TECHNICAL SERVICE BULLETIN

INTERMITTENT HARD STEERING (VEHICLES EQUIPPED WITH EPS ONLY)

This bulletin provides information relating to the service of the vehicle speed sensor and adapter cord. Sorento EX vehicles produced before 10/6/04 may intermittently have variations in the level of power assist during driving or parking. Diagnostic trouble code (DTC) C1012 may be stored in the EPS control module.

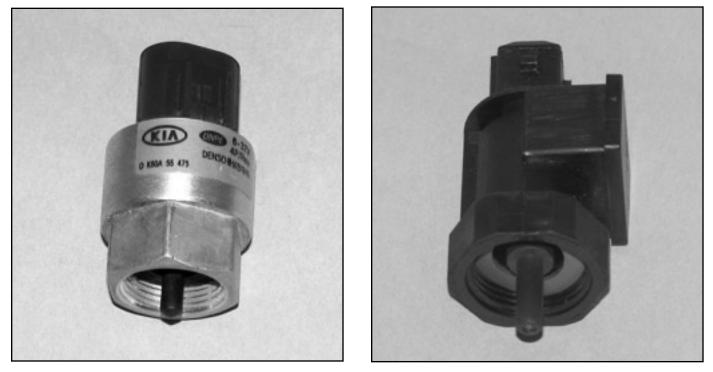
Old

New

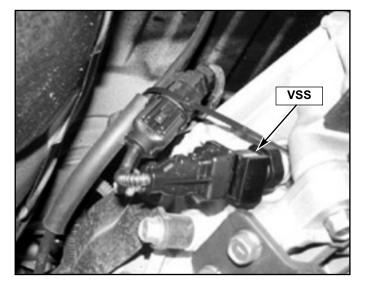
Remove and replace vehicle speed sensor in the transmission on 2WD vehicles. Torque new speed sensor to 60 in-lbs or 7.5 Nm.

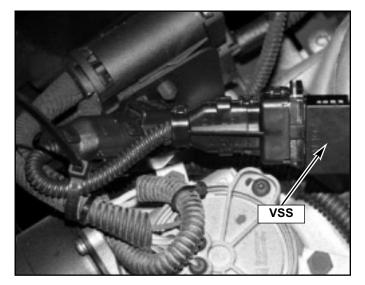
2. If equipped with 4WD remove and replace the vehicle speed sensor in the transfer case. Torque new speed sensor to 60 in-lbs or 7.5 Nm.

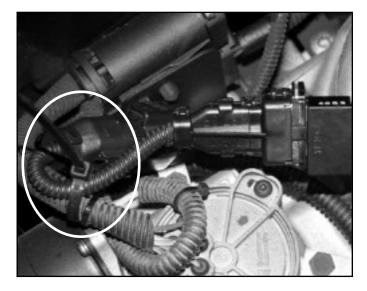
3. Install a new vehicle sensor adapter cord to the new sensor. Connect the vehicle harness, then tie-up wiring with tie-strap to prevent vibration and interference (as shown).
